**METROPOLITAN GOVERNMENT OF NASHVILLE AND DAVIDSON COUNTY**

**STAFF RECOMMENDATION**  
**1905 Holly Street**  
**October 21, 2020**

**Application:** New Construction—Infill and Outbuilding; Setback Determination  
**District:** Lockeland Springs-East End Neighborhood Conservation Zoning Overlay  
**Council District:** 06  
**Base Zoning:** R6  
**Map and Parcel Number:** 08314001900  
**Applicant:** Cheyenne Smith  
**Project Lead:** Melissa Sajid, [Melissa.sajid@nashville.gov](mailto:Melissa.sajid@nashville.gov)

EXTERIOR  
ELEVATIONS

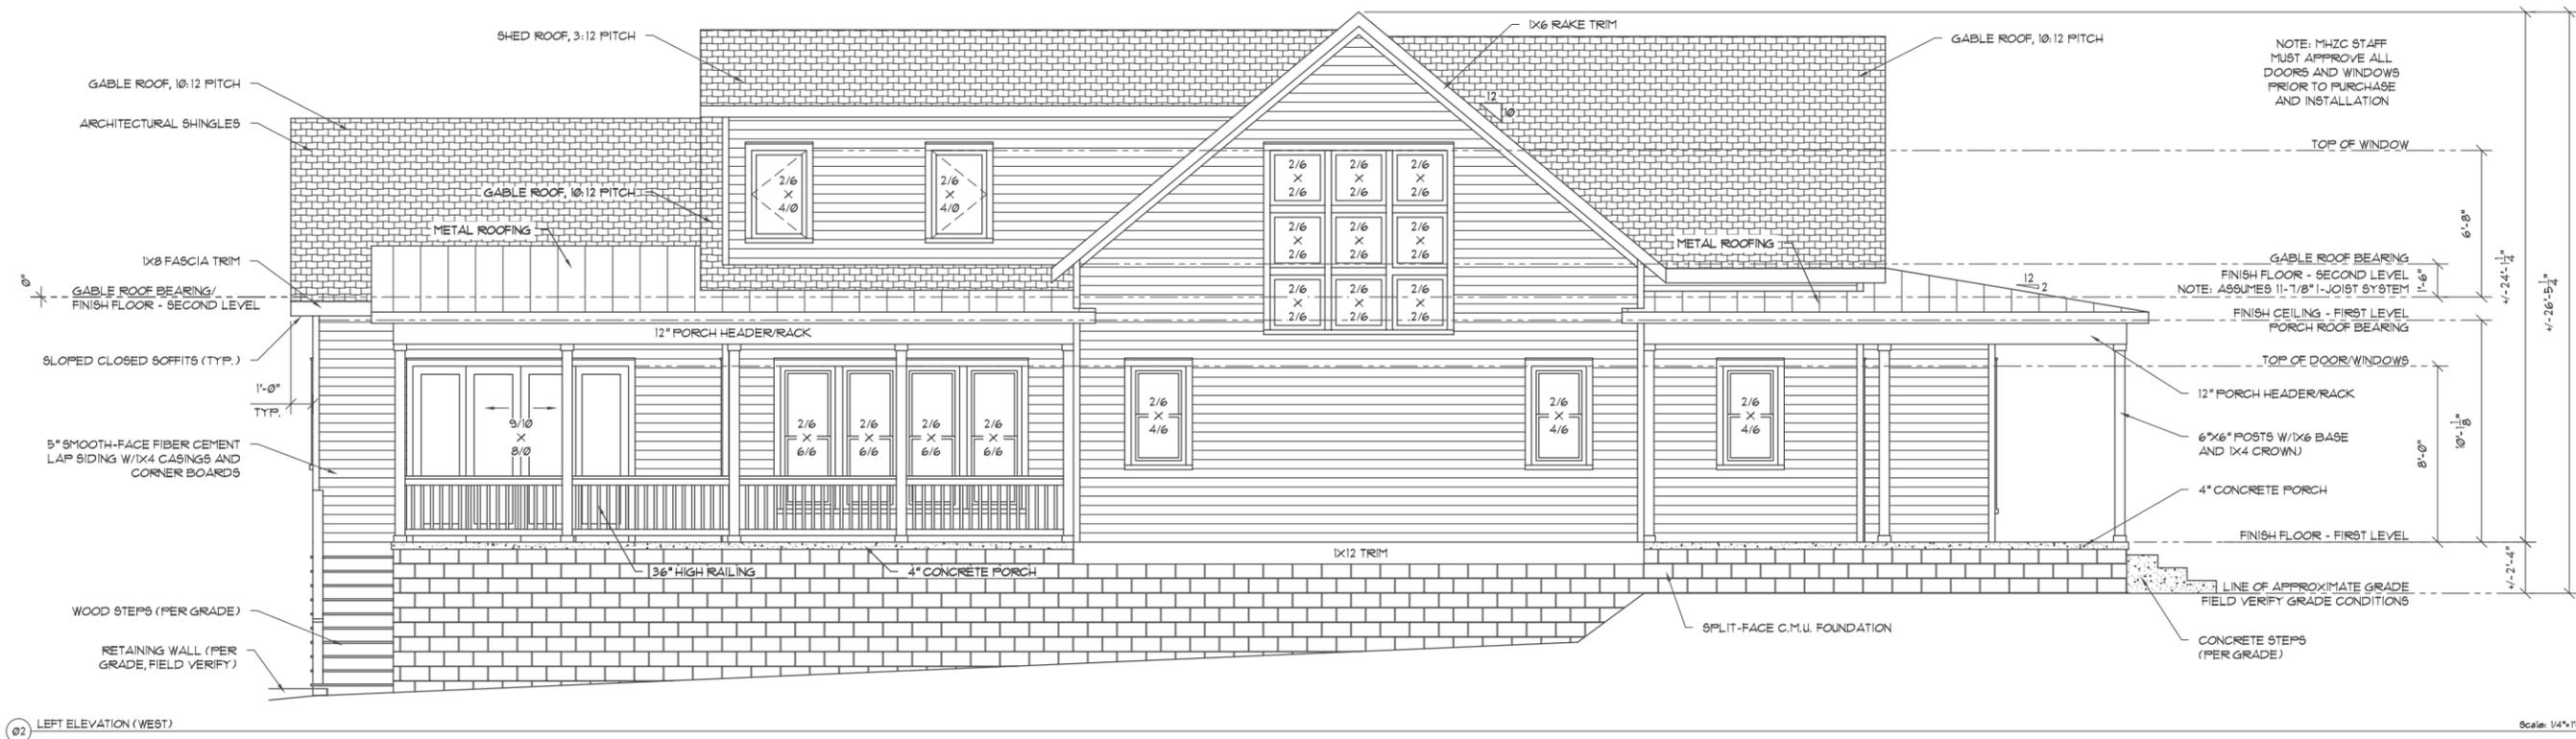
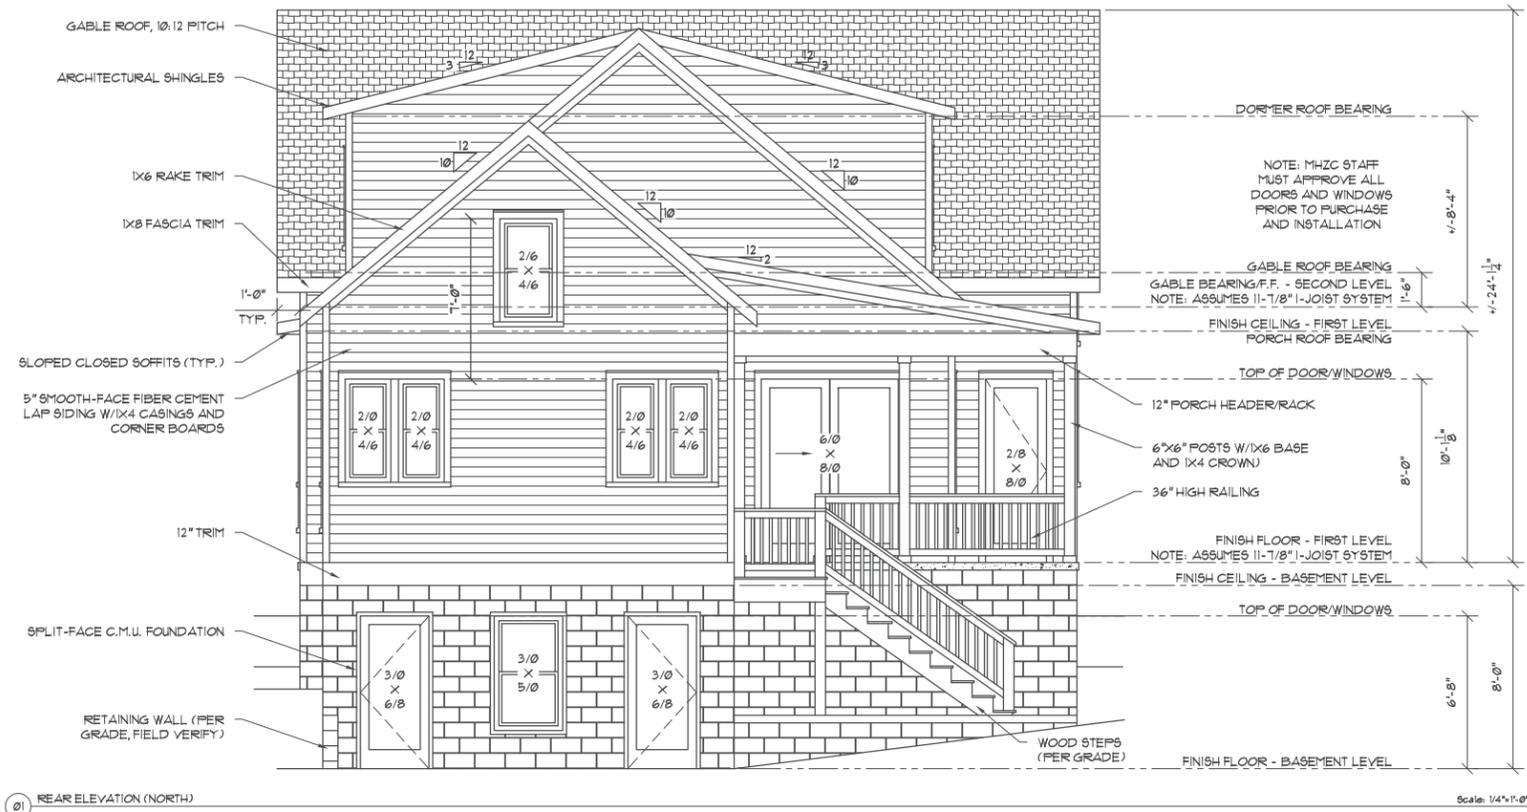
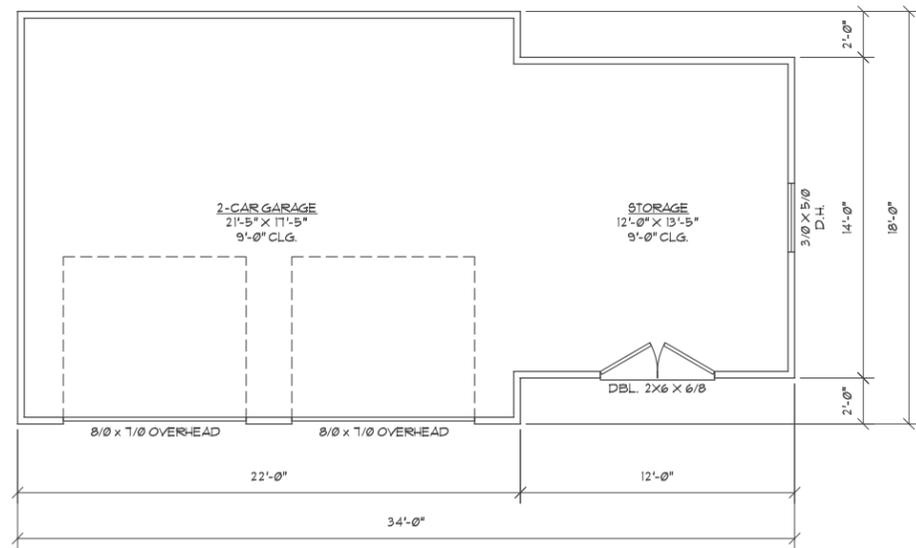
**Height & Scale:** The new principal building will be one-and-one-half-stories, with a roof-ridge height of approximately twenty-six feet, five inches (26'-5") from grade and an eave height twelve feet, three inches (12'-3") from grade, with a foundation height of two feet, four inches (2'-4") at the front, according to the grade. The historic context on this block is composed of one-story and one and one-half story houses, ranging from twenty-four feet (24') to thirty-five feet (35') tall. Staff finds that the height of the proposed new building is compatible with the surrounding context and similar to what the Commission approved for infill at 1903 Holly Street.

The infill is twenty-three feet, four inches (23'-4") wide at the front and widens to a maximum width of thirty-four feet (34') twenty-two feet (22') behind the front porch. Historic houses on the block range from twenty-eight feet (28') to forty feet (40') wide, with similar porch depths. The infill is eighty-two feet, eight inches (82'-8") deep. Staff finds that the proposed depth is appropriate as it is similar to nearby houses with additions and the last twenty feet (20') of the infill has a single-story form.

**Roof form:** The primary roof form is a cross-gable with a pitch of 10/12. The front and side/rear porches have shed roof forms with a 2/12 pitch that is common for porch roofs. The rear wing of the building incorporates side dormers with a 3/12 pitch; as proposed, both dormers are inset two feet (2'). The roof pitches are compatible with roofs on historic houses nearby.

Proportion and Rhythm of Openings: Most of the windows on the proposed infill are generally twice as tall as they are wide, thereby meeting the historic proportions of openings. On the left-side façade, however, there is a large collection of windows beneath the side gable that is more of a square. Staff finds these windows to be appropriate as they are located approximately at the midpoint of the house and are not likely to be highly visible from the street. There are no large expanses of wall space without a window or door opening.

1. The finished floor height shall be consistent with the finished floor heights of the adjacent historic houses, to be verified by MHZC staff in the field;
2. The front setback shall be consistent with the setbacks of the adjacent historic houses, to be verified by MHZC staff in the field;
3. MHZC staff shall review the final selections for the windows, doors, garage doors, roof colors, and porch columns prior to purchase and installation; and
4. The utility connections and HVAC units shall be located behind the midpoint of the building on a non-street facing façade.

GARAGE FLOOR PLAN  
AND ELEVATIONS

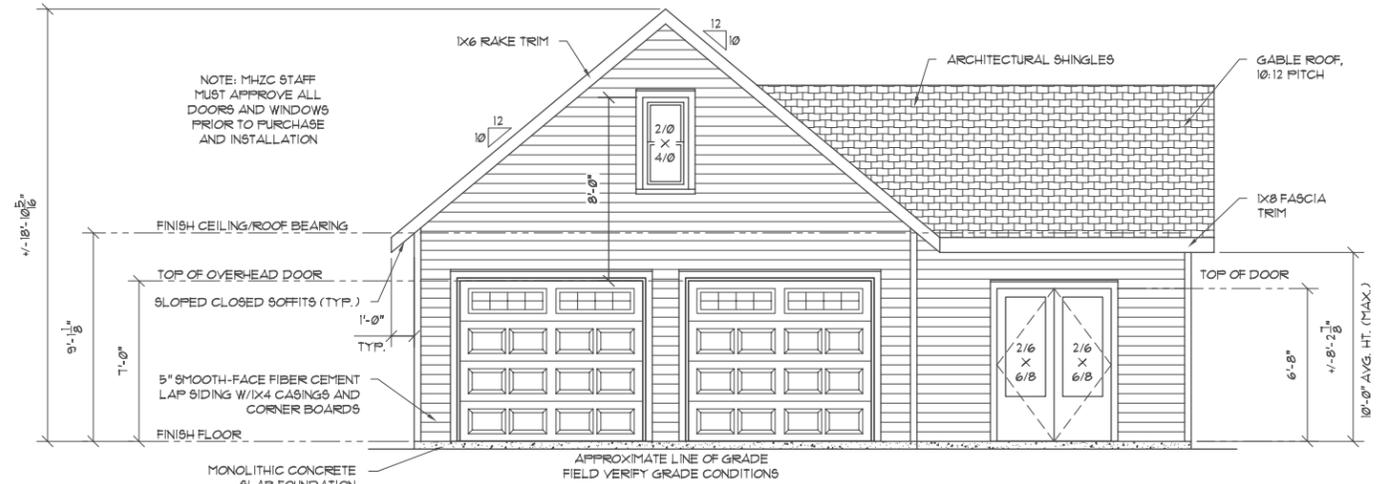
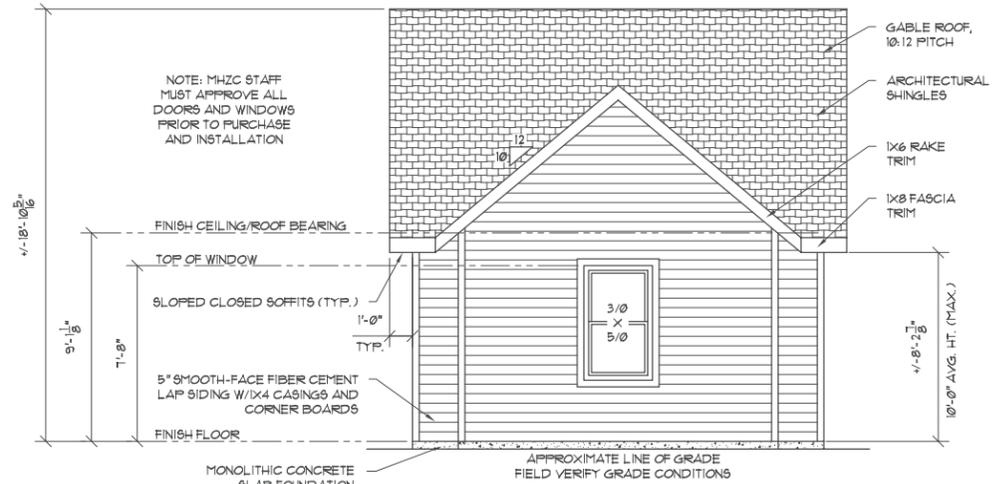
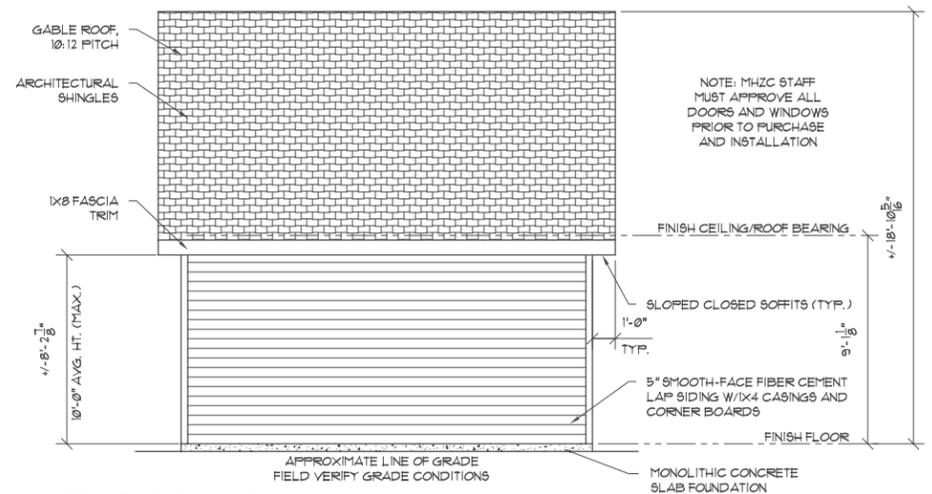
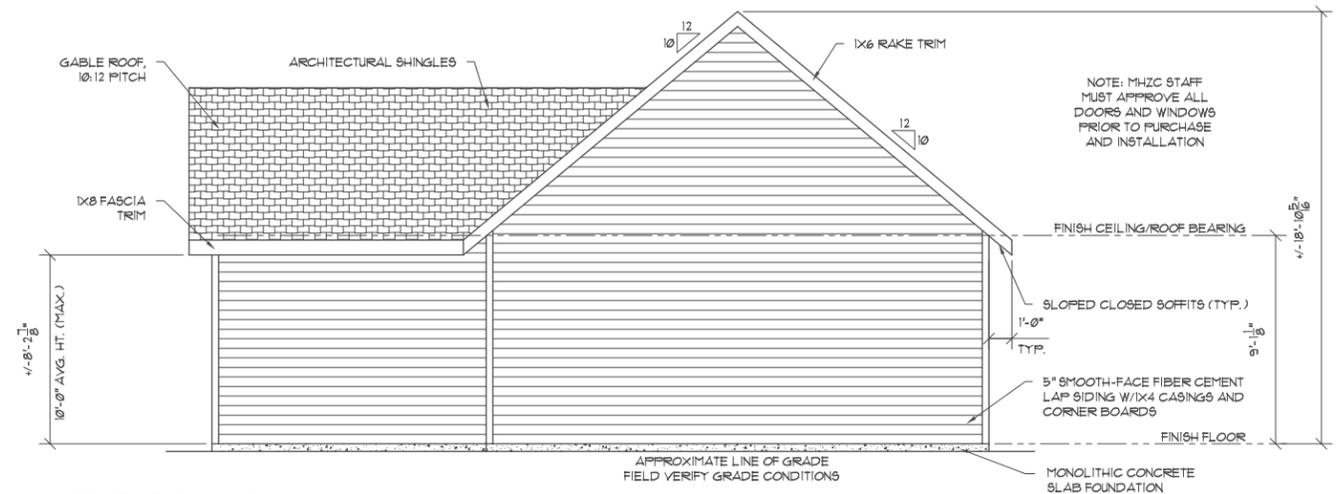
Potential 1-Story or 1.5-Story Outbuilding	Proposed Outbuilding
Ridge Height	25' (not to exceed principal building height)	18'-11"
Eave Height	10'	9'-1"

The footprint size, roof, height, and eave heights are compatible with the corresponding heights of the house and are less than the maximums allowed by the design guidelines. Staff finds that the application meets Section III.H.1. of the design guidelines for height and scale.

The proposed outbuilding has a cross-gable roof form with a 10/12 pitch similar to the primary roof form and pitch proposed for the infill. Staff finds that the roof form of the proposed application meets Section III.H.3 of the design guidelines for roof form.

The outbuilding meets all setbacks except for the rear. The applicant has requested a setback determination to reduce the rear setback from three feet (3’) to one foot (1’). The primary reason for the request is a sewer line and associated easement that are located on the rear third of the lot (Figure 3). The location of the easement makes it difficult to locate a detached outbuilding. Staff finds that the setback determination in this case could be appropriate not only due to the location of the sewer and easement but also because the scale of the outbuilding is modest.

With the condition that the final selections for the windows, pedestrian and vehicular doors, and roof color are approved prior to purchase and installation, staff finds that the project meets Section III.H.5. for new construction-materials on outbuildings.
